T7PX/T7XC Software Update Method

Modification of MC970CR setting function.

Improvement in SR mode setting

Futaba | **T7PX Additional function** | V2.2

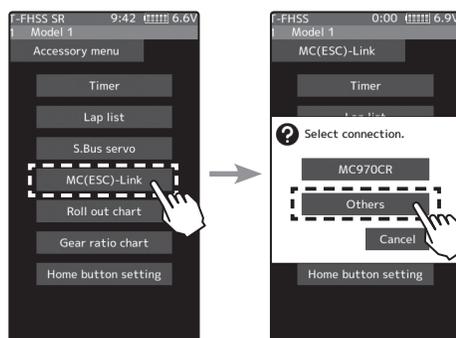
When the trim or the dial is operated, the value of the function is displayed for a few seconds at the top of the screen.

The trim/dial is assigned to the gyro mixing function.

The value of the gyro gain is indicated to the top of the screen for several seconds.

"S.Bus servo" screen of version V2.0 to V2.2

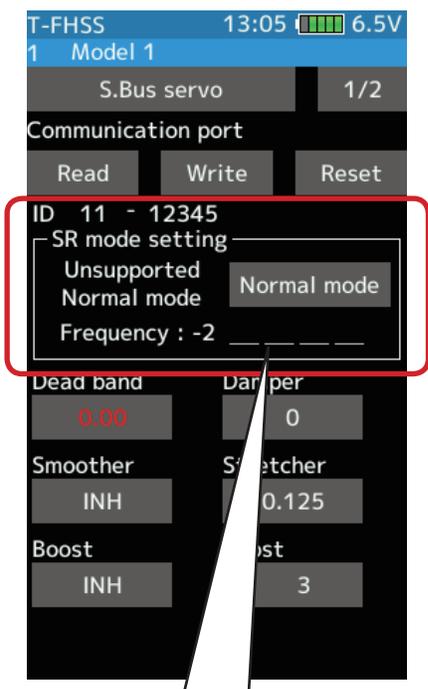
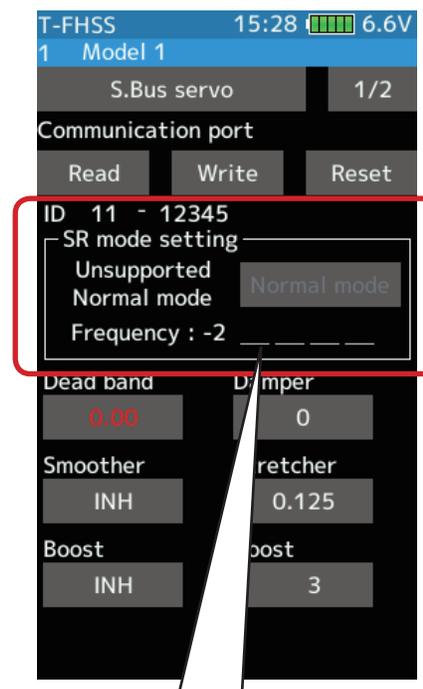
Even if a servo that is not compatible with SR mode is connected to a T7PX/T7XC with softwareV2.0 to V2.2, the transmitter can switch the servo to SR mode, but the incompatible servo will not work and the servo program is damaged when you forcibly switch the servo to SR mode. Thus, the servo does not work. So, please never switch when you connect an incompatible servo to SR mode.

Even if a servo that is not compatible with SR mode is connected, you can switch the servo to SR mode, but the servo will not work and damaged if you switch it to SR mode

When connecting a servo that is not compatible with SR mode, a message "Unsupported" is displayed on the screen, but you can operate the SR mode select button.

The software has been improved so that a transmitter prohibits you from switching an incompatible servo to SR mode.

If you connect a servo that is not compatible with SR mode, the screen forbids you switching it to SR mode.

When connecting a servo that is not compatible with SR mode, you cannot operate the SR mode switching button.
